DOCUMENTS FOR REVIEW AND FILES LOCATION

Please charge time to 5600015- 102. Design Consultant response period: 12-22-2014 to 1-12-2015.

TOWN OF COLCHESTER COUNTY OF CHITTENDEN PROPOSED IMPROVEMENT SIDEWALK AND RESURFACING PROJECT STP 5600(15)

**CONCEPTUAL PLANS
NOVEMBER 24, 2014**

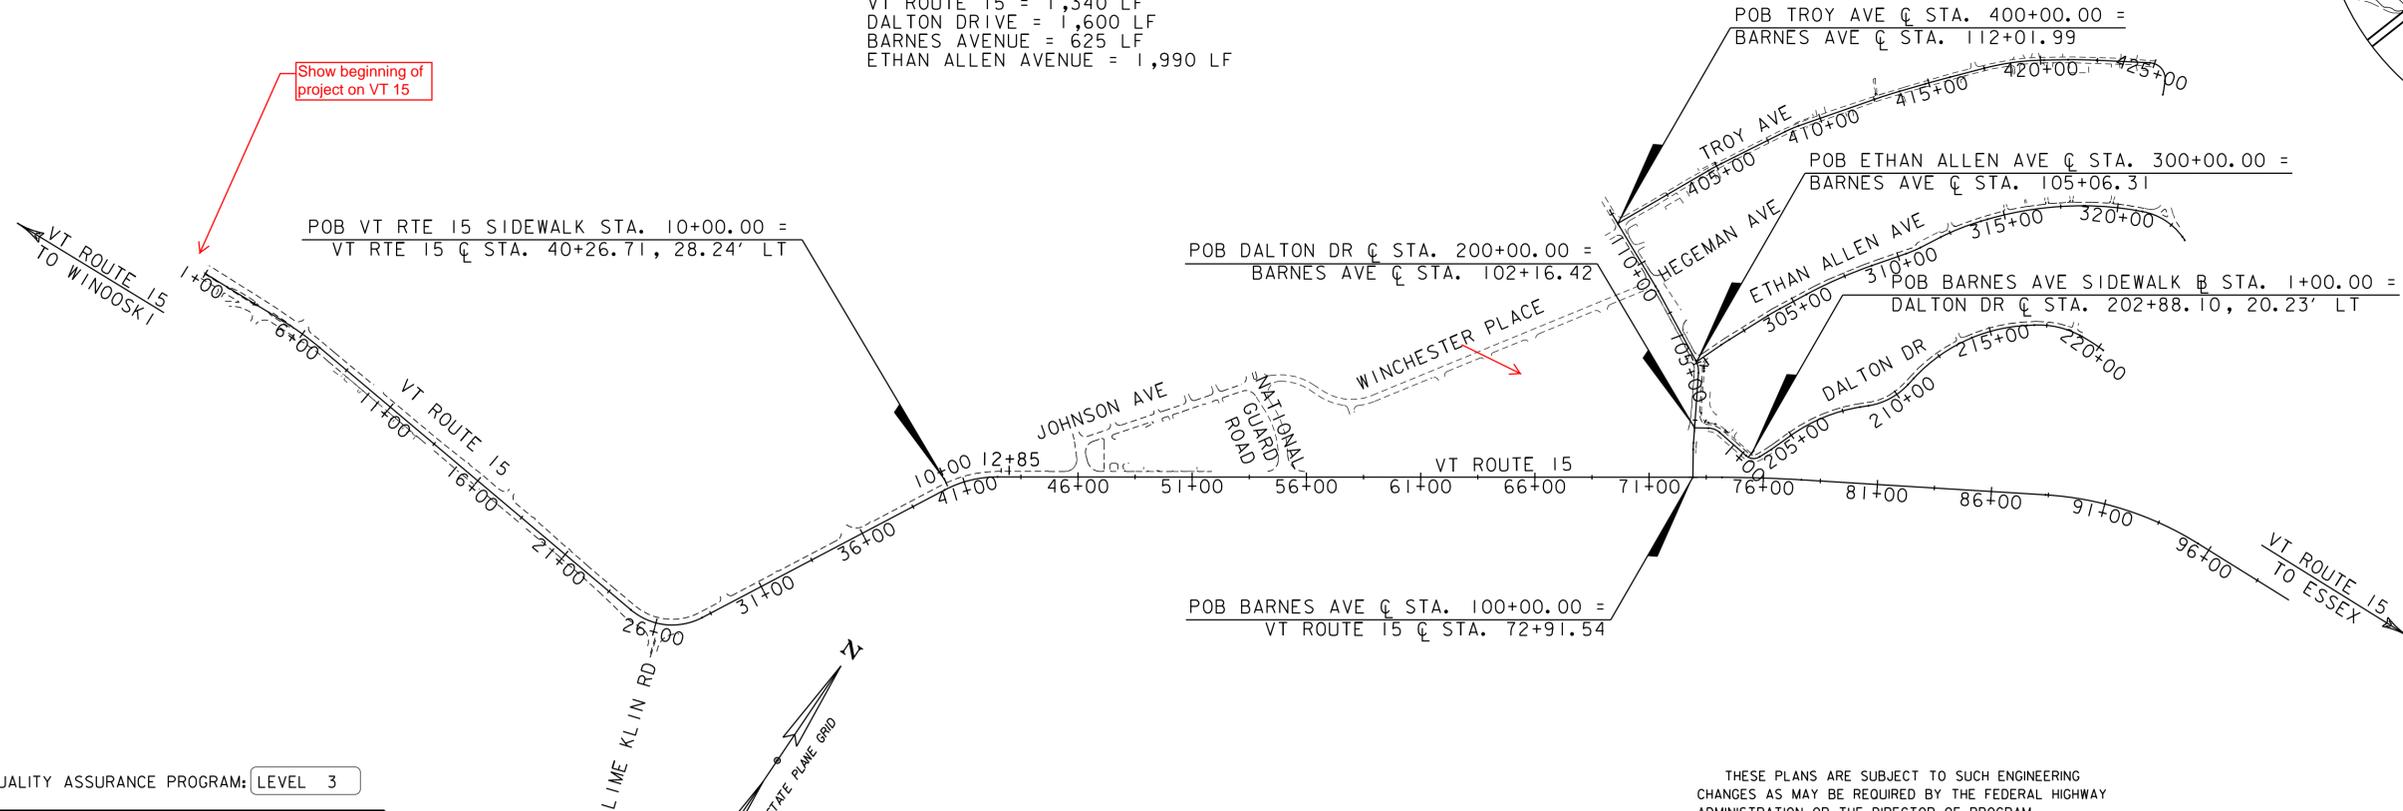
All CCTA bus shelters should be shown and any modifications to their access to sidewalk needs to be addressed.

Show beginning of project on VT 15

### BARNES & TROY AVENUES TYPICAL SECTION

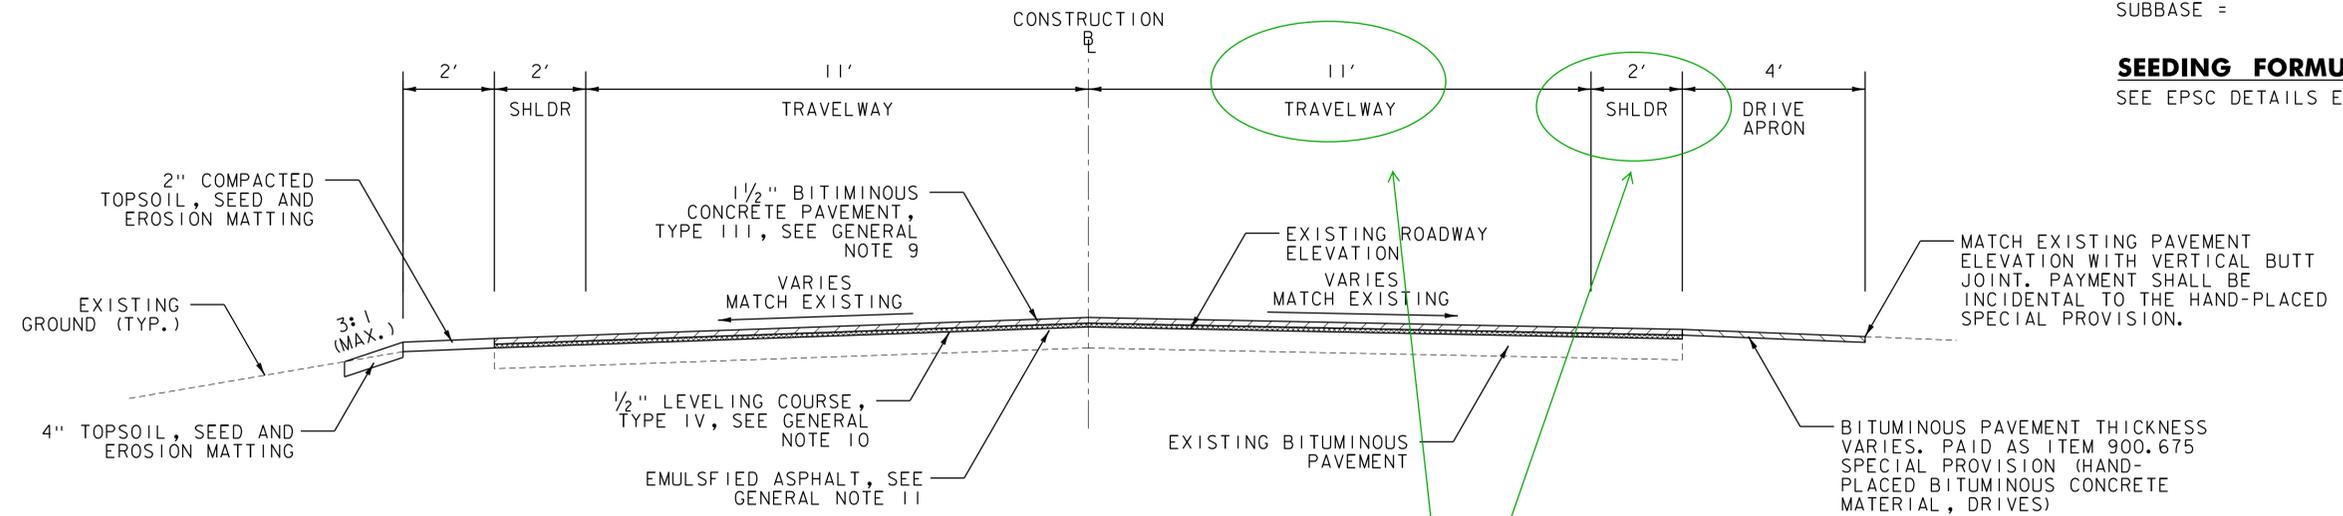
For these low volume roads, could this be a 10 ft. lane with a 3 ft. shoulder? That would be better for bicyclists.

## PAVING LIMITS FOR DRIVES

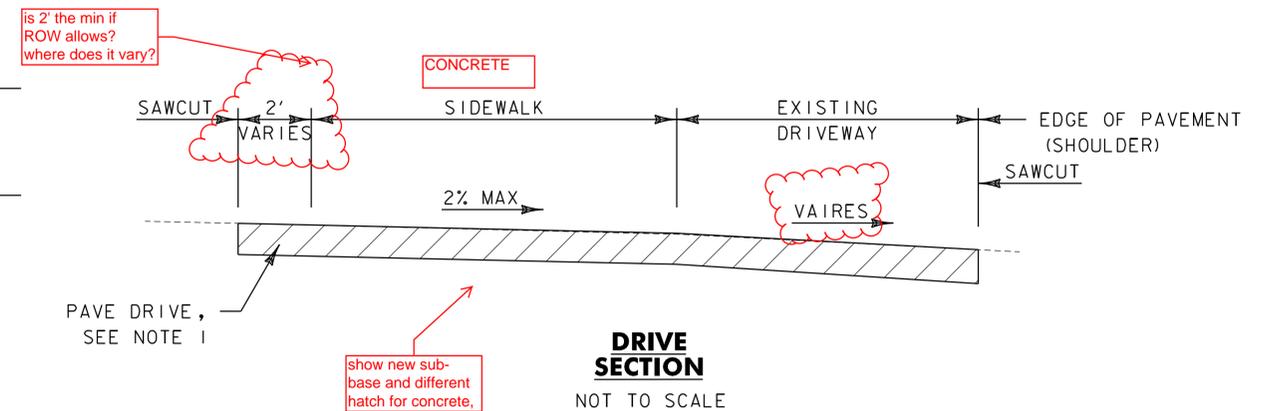
CLARIFY WHEN YOU WOULD REPLACE MORE...WITH RE APPROVAL?

**CURB RETAINING  
WALL DETAIL**

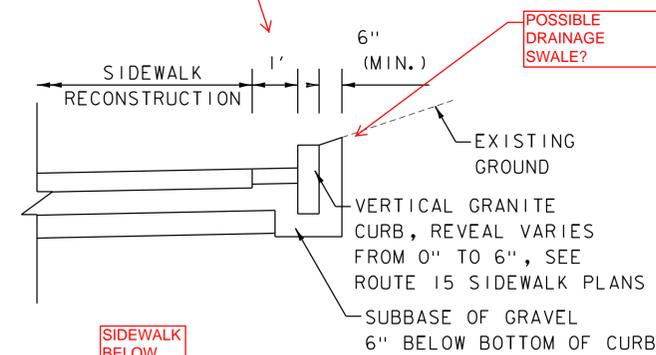
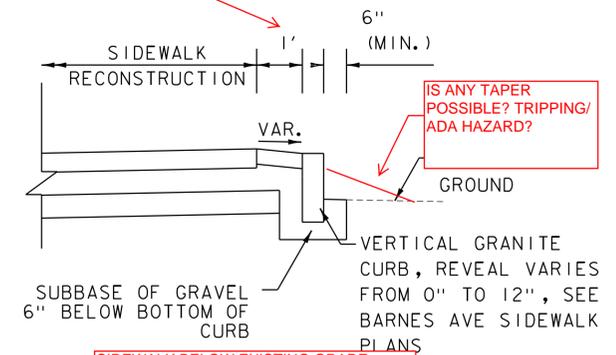
DO WE REALLY WANT TO CALL THESE RETAINING WALLS?

PROJECT NAME:	COLCHESTER	FILE NAME:	Alignment Plans.dgn	PLOT DATE:	11/24/2014
PROJECT NUMBER:	STP 5600(15)	PROJECT LEADER:	J. LEINWOHL	DRAWN BY:	T. DUGUAY
		DESIGNED BY:	T. DUGUAY	CHECKED BY:	J. LEINWOHL
			<b>ROUTE 15 ALIGNMENT PLAN AP-02</b>	SHEET	12 OF 35

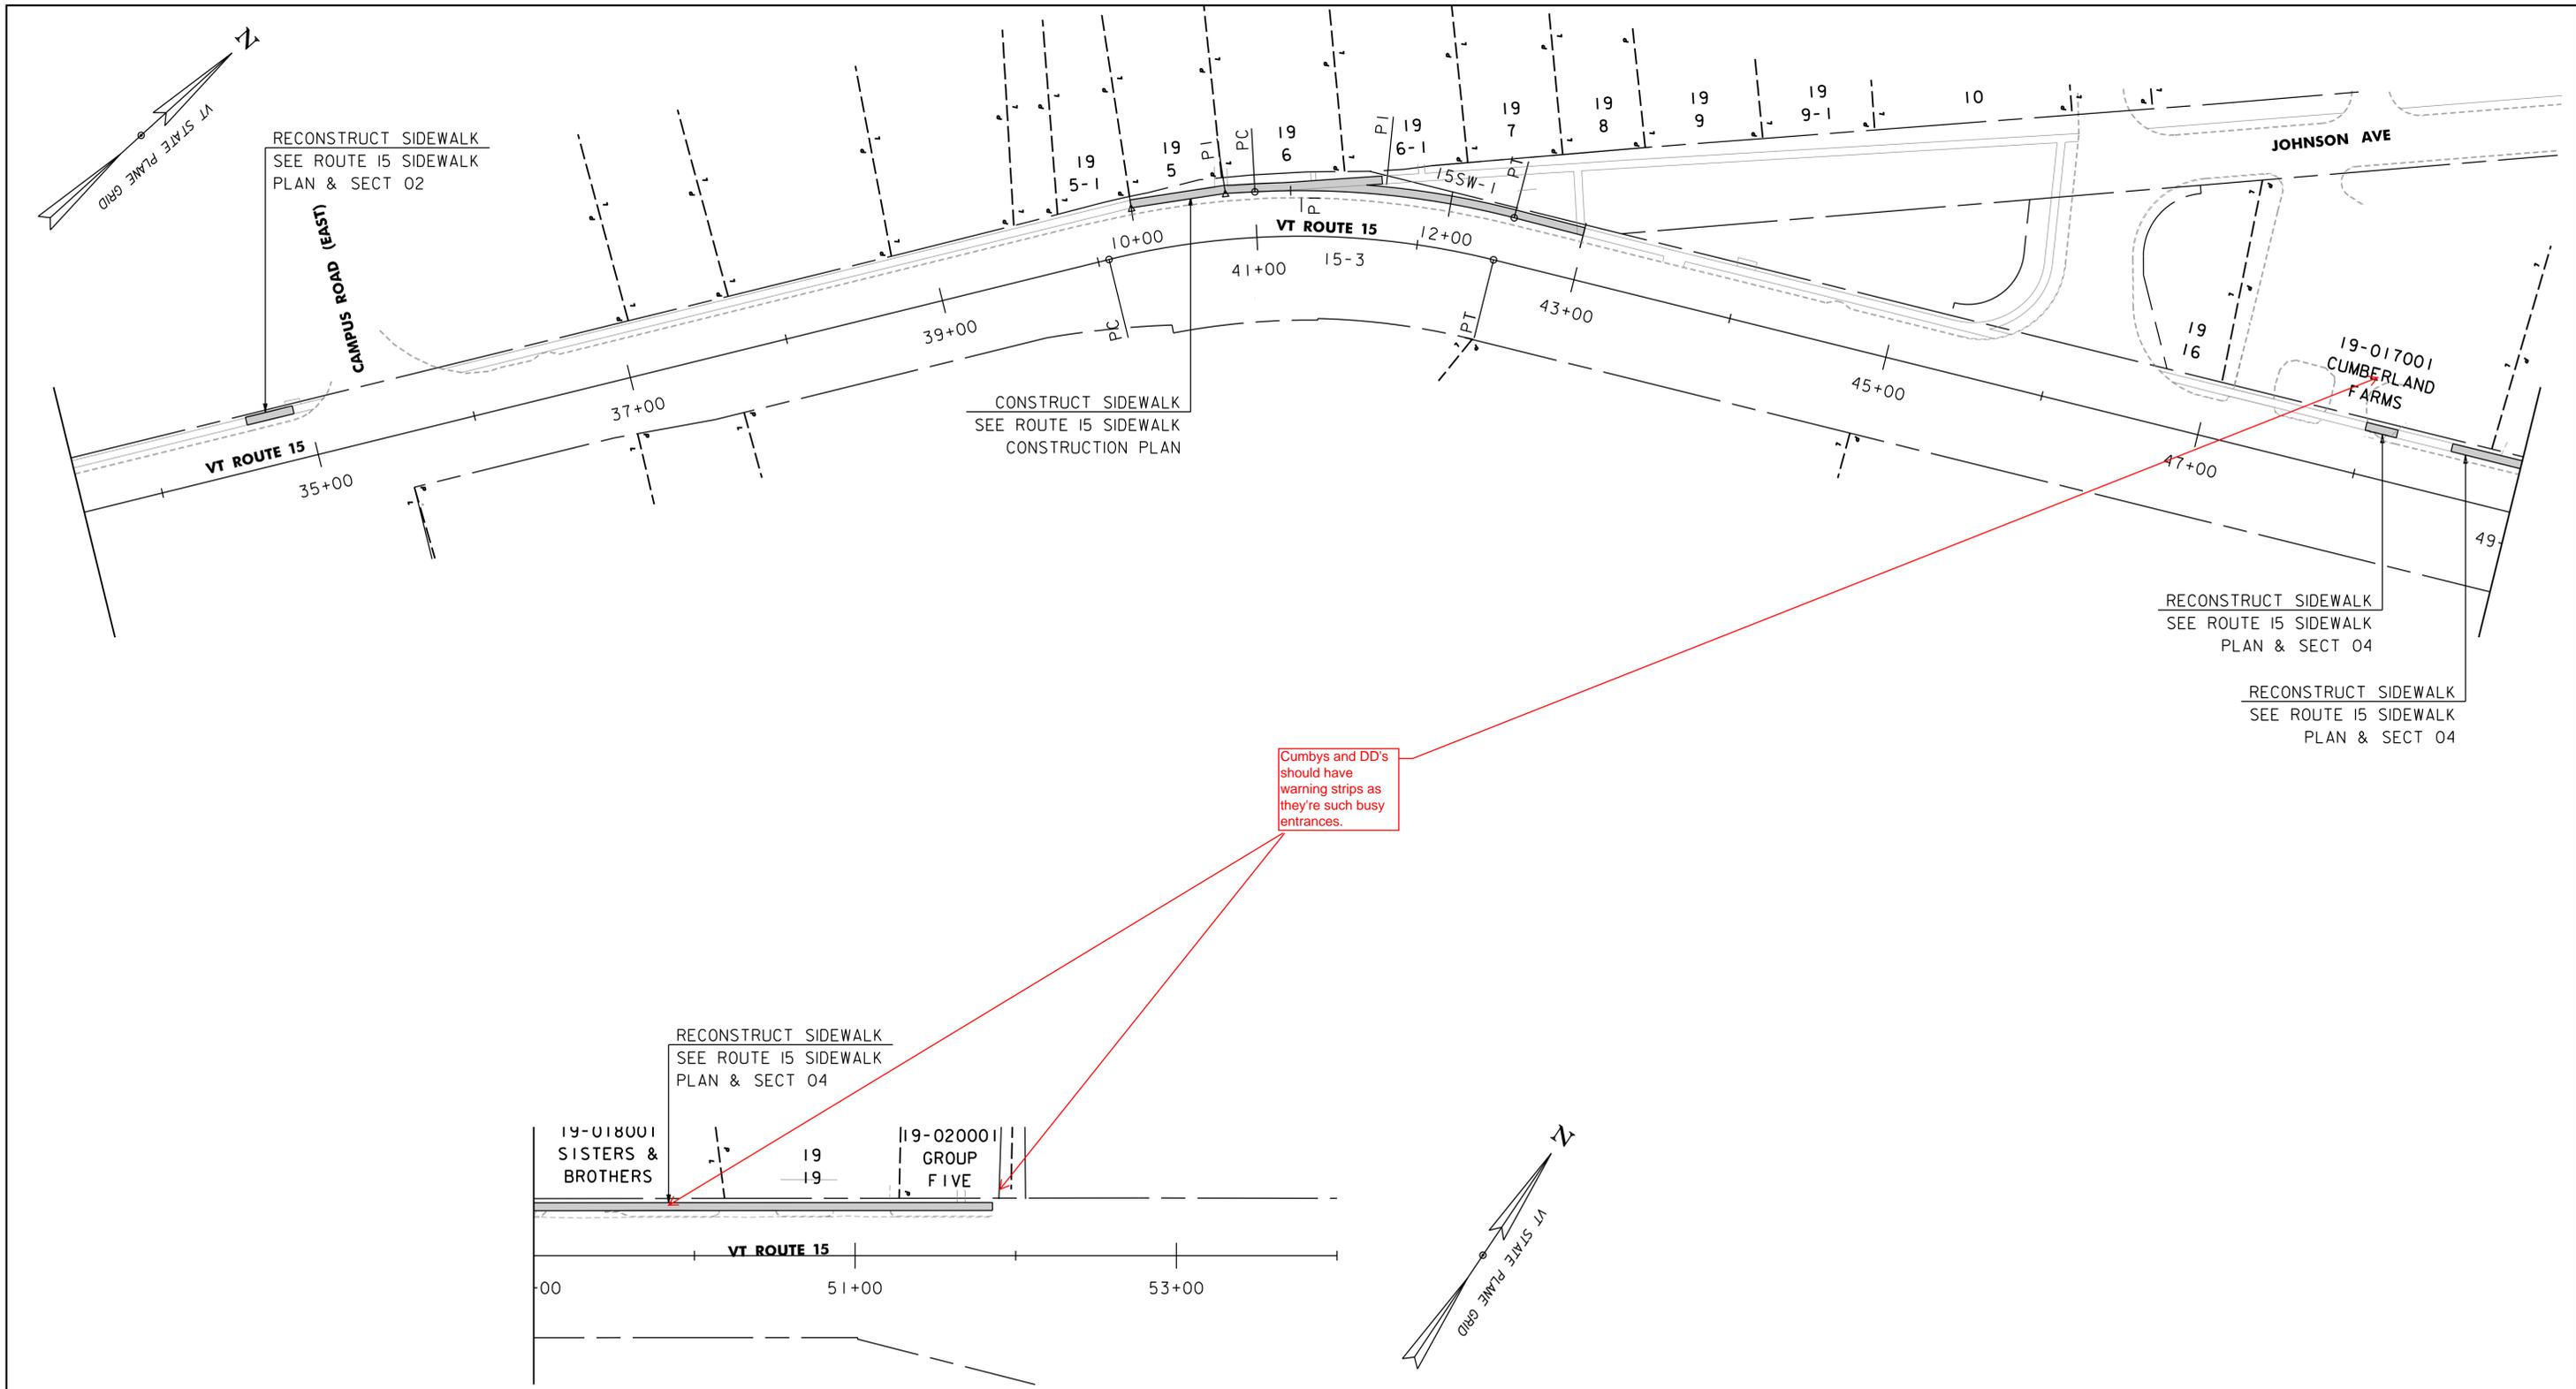
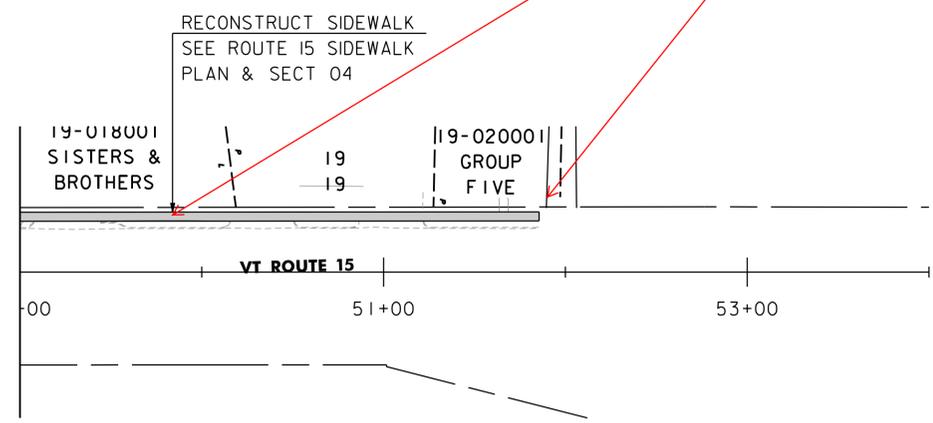
Cumbys and DD's should have warning strips as they're such busy entrances.
